BOARD of ADJUSTMENT

Public Hearing
~ Agenda ~

Tuesday
August 24, 2021

2. Public Hearing: City Council remand in part of a Conditional Use Permit application for a proposed 80' Wireless Communication Facility (WCF). The WCF will accommodate three carriers within a fully enclosed 800 sf lease area and would resemble a church tower per MCC 4-3-5(H) (ACTION ITEM)

Figure C.1—New AT&T 4G LTE Coverage

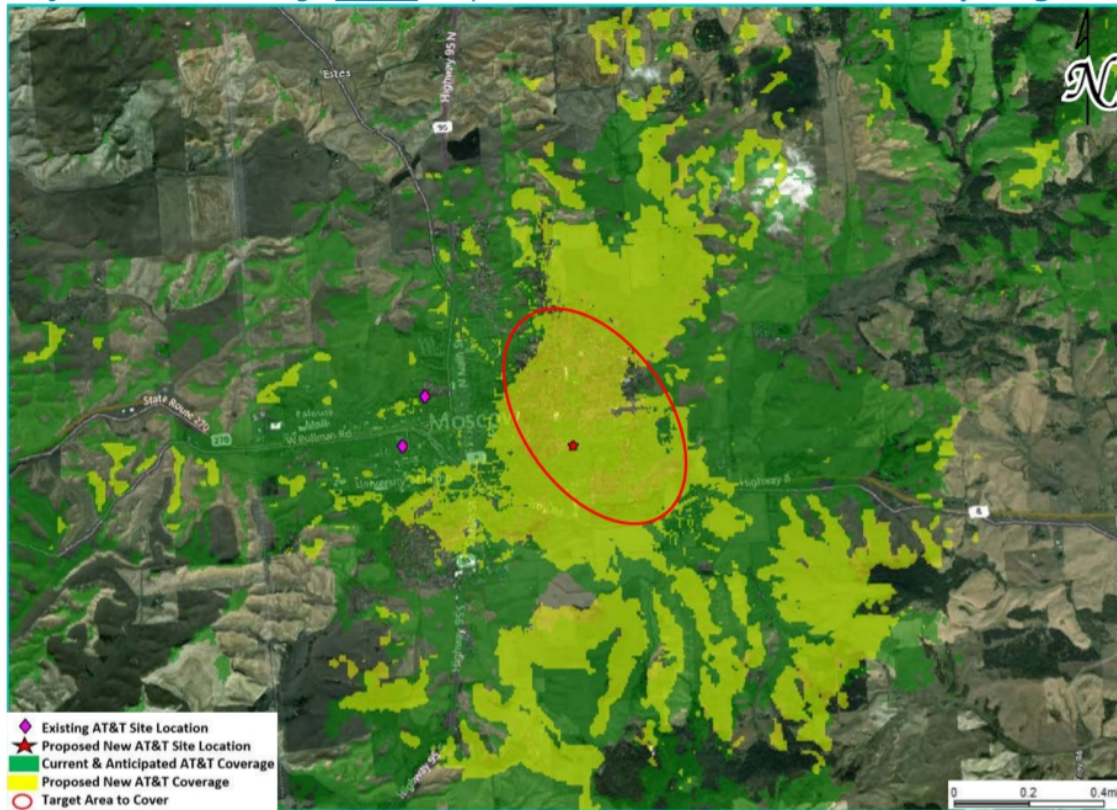
Using their own map and verbiage, the map below shows the additional service that will be added using 'line of site' technology. We can use their map as a viewshed map (the geographical area from which the

A-1.3

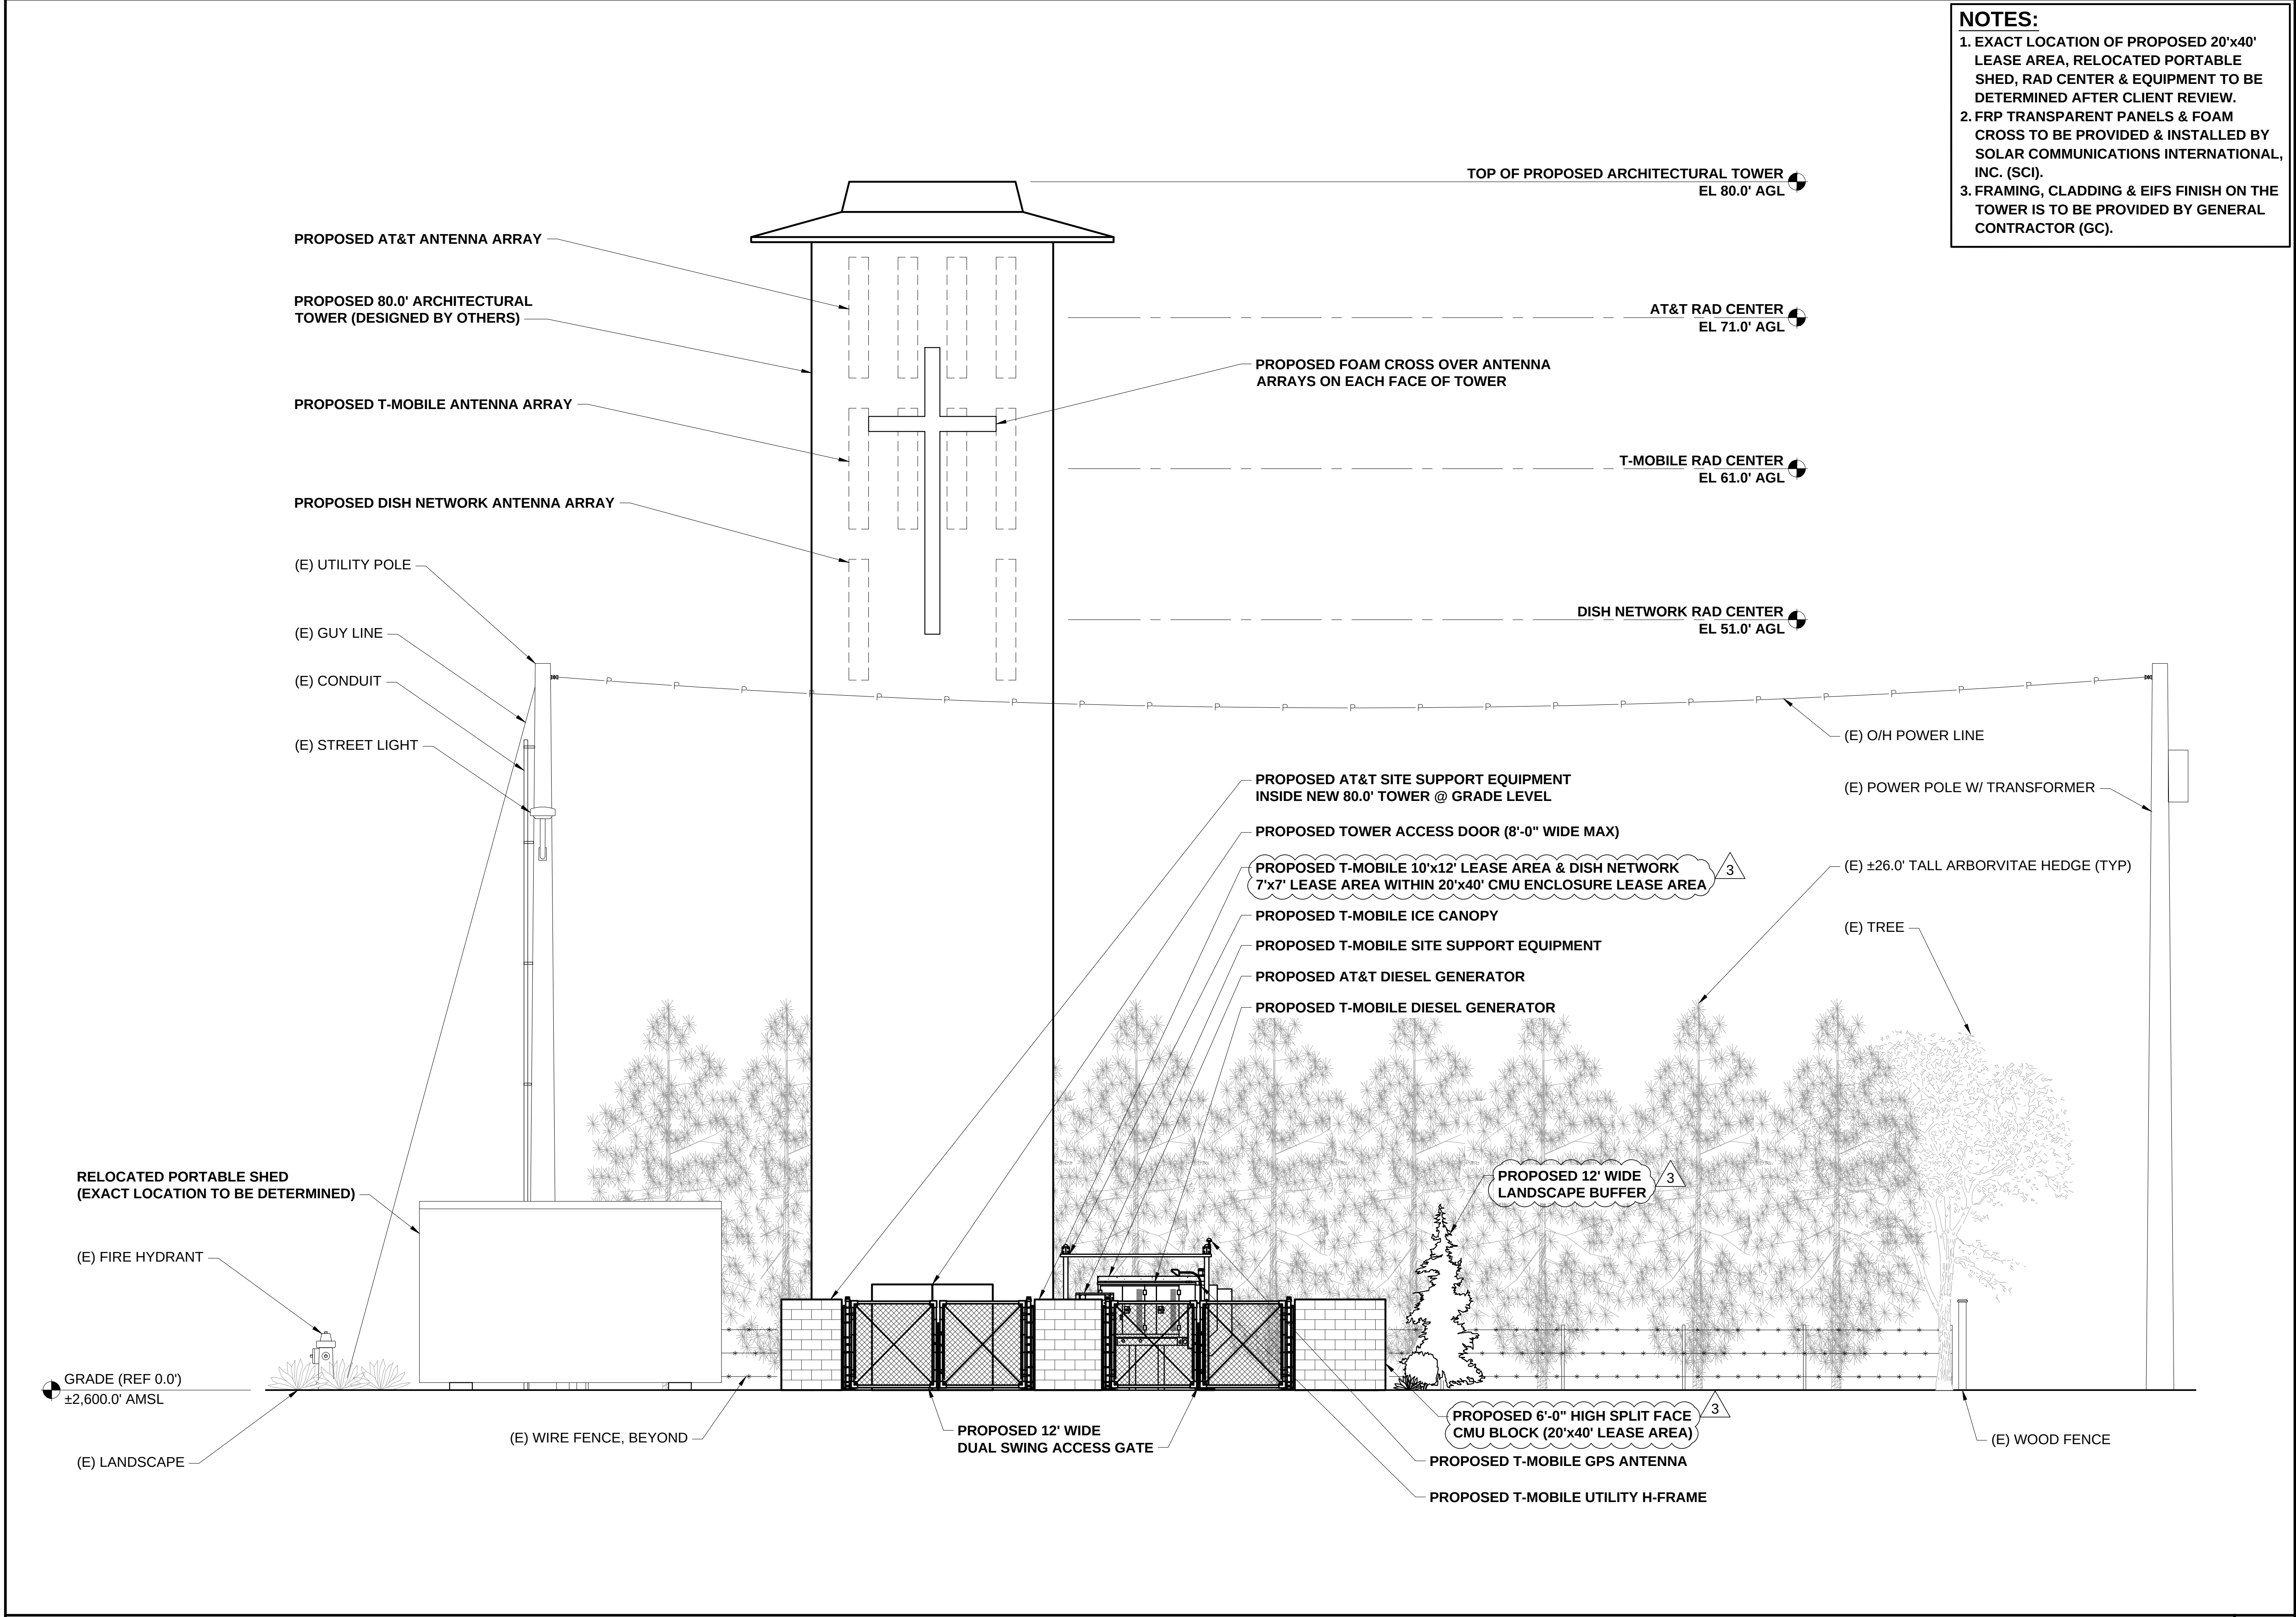
APPLICANT RESPONSE: See Attachment 3 – Zoning and Elevation Drawings – Sheet A-1.3 for Asphalt Parking Area.

A-2

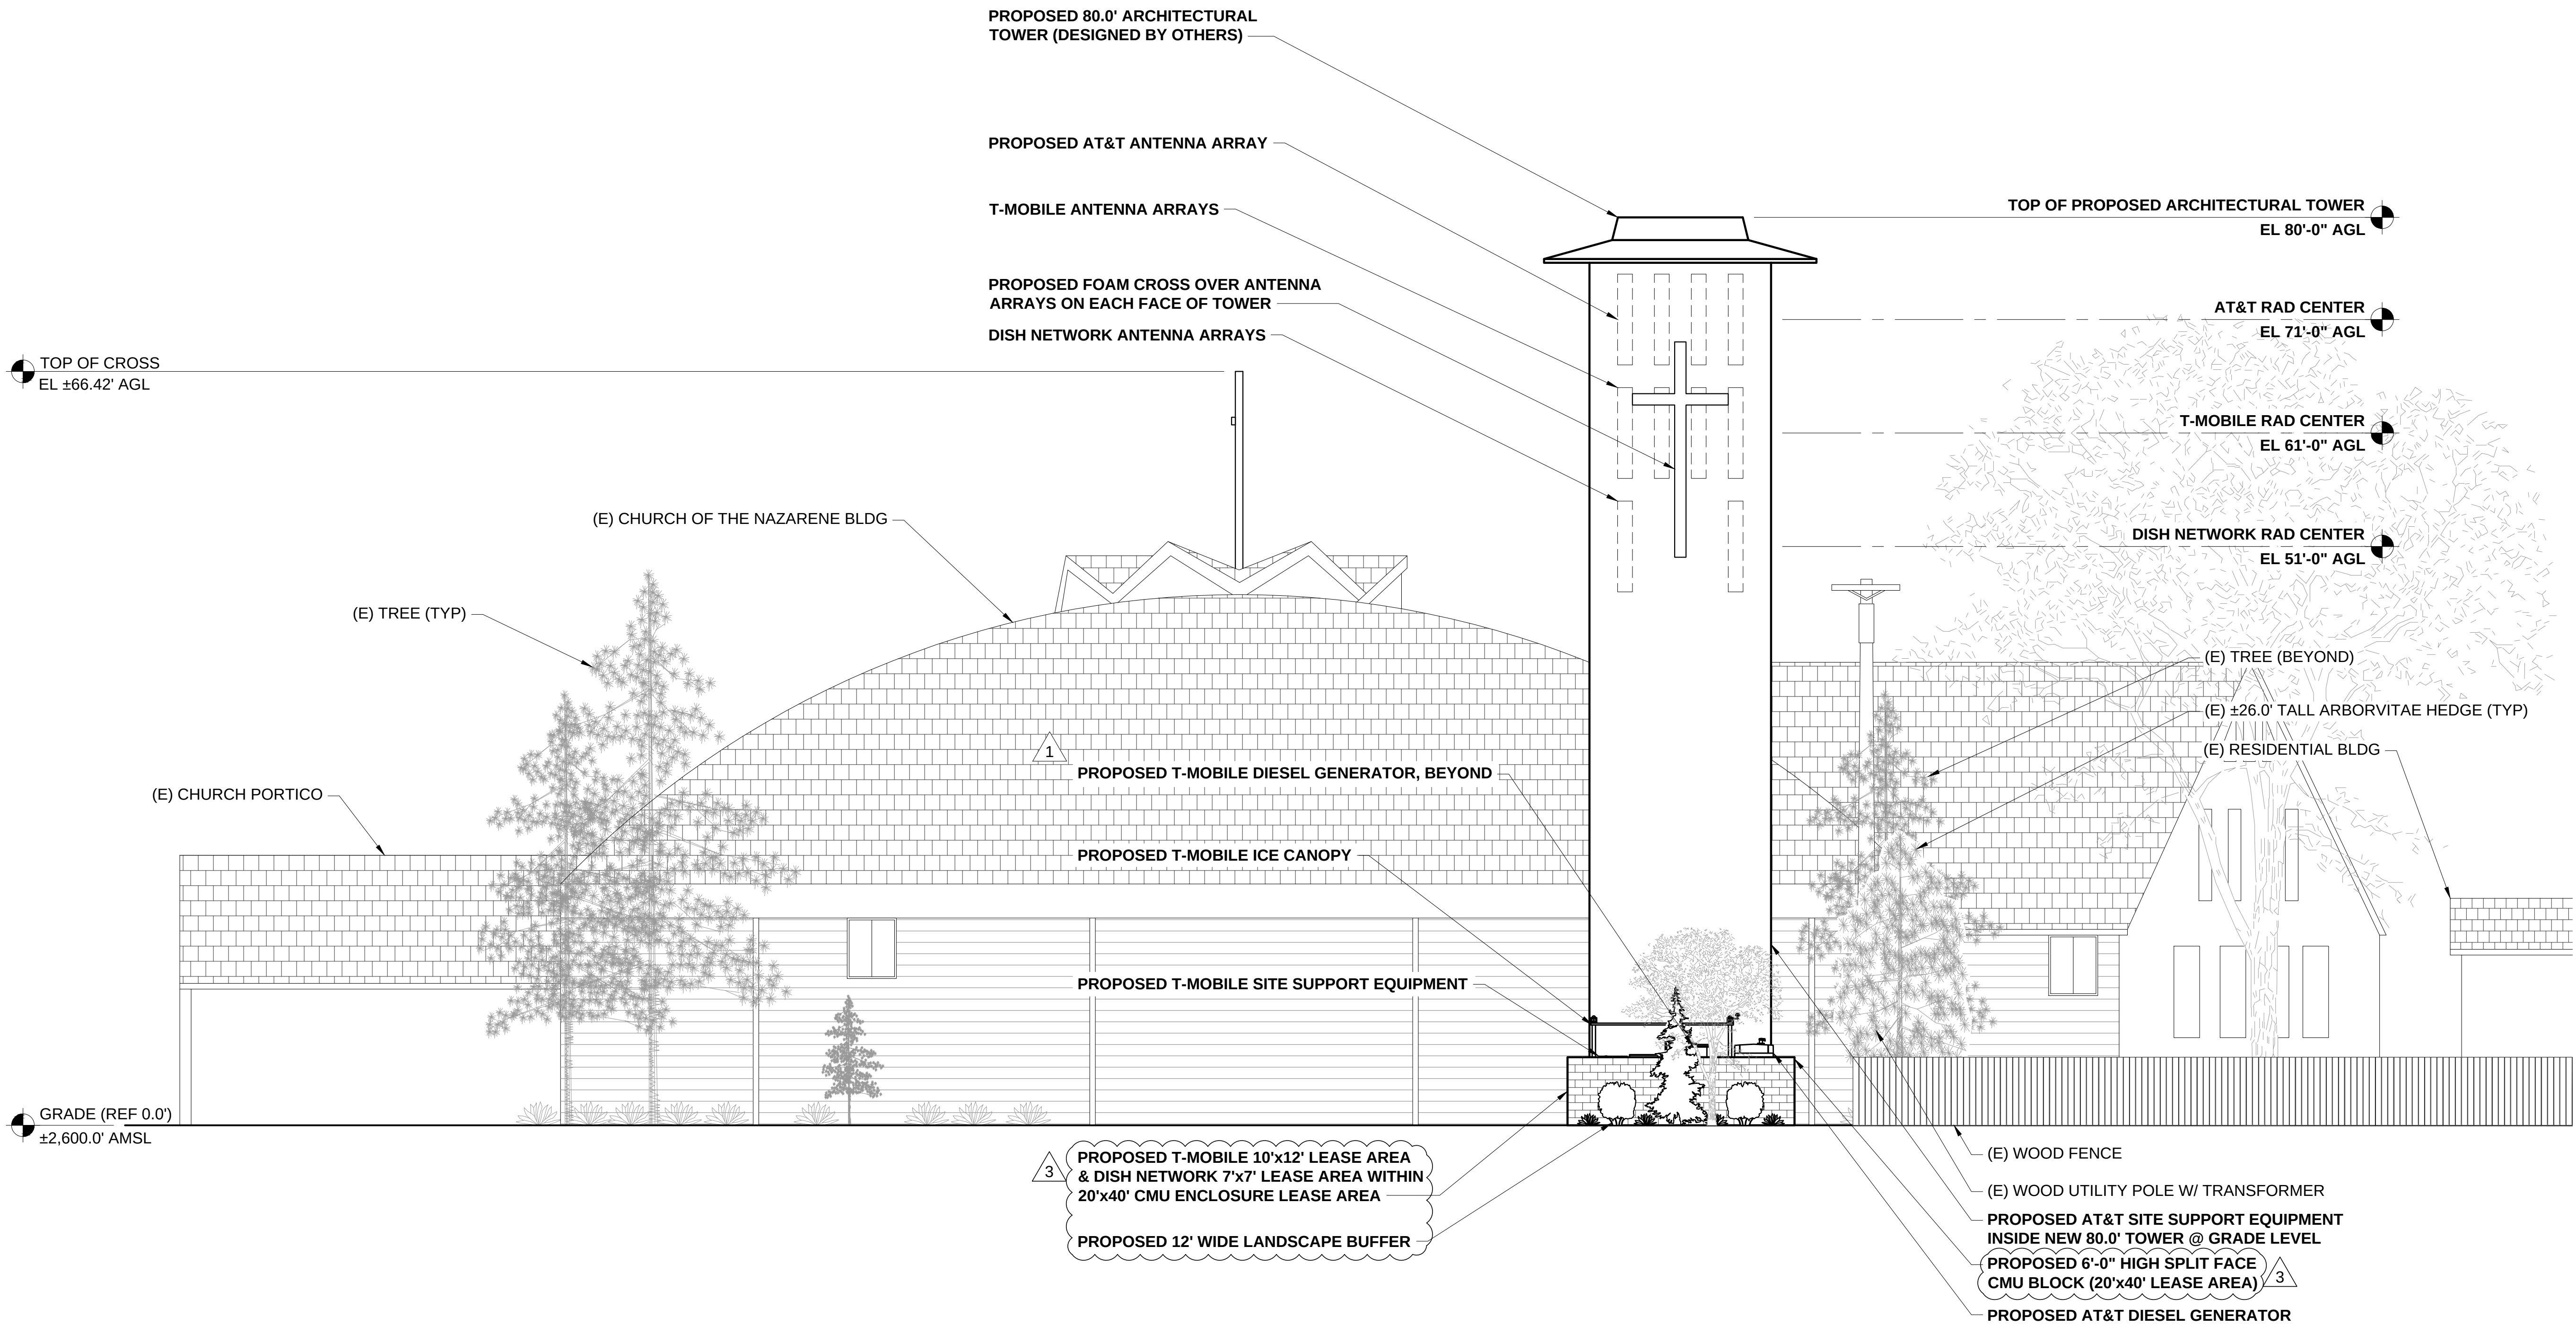
23 BUSCH: Alright, I did find- this is Gregg Busch, for- with Wireless Policy Group, by the way.
24 I did find the answer to your question. And, unfortunately, the drawings do not go
25 into that level of detail. I'm looking at sheet A-2 of the drawings- most recent version
26 of the drawings, and unfortunately it says "framing, cladding, and EIFS finish on the

3. Under item **General Information → 7 → Criteria #3** of the filing application, applicant indicates "All ground equipment will be fully screened with existing landscaping and a six foot (6') tall fence. Construction will create some noise that will last approximately one month. Two diesel generators will run in the event of a power outage, and once a week for one hour for maintenance." Application drawings A-1.2 2 and following illustrate that no additional landscaping vegetation will be used to provide a visual barrier for the ground structures to be installed (e.g., diesel generators, etc.). Only existing Arborvitae vegetation will be used in addition to newly installed 6-foot cedar fencing (Drawing A-2 2). If not routinely maintained (i.e.,
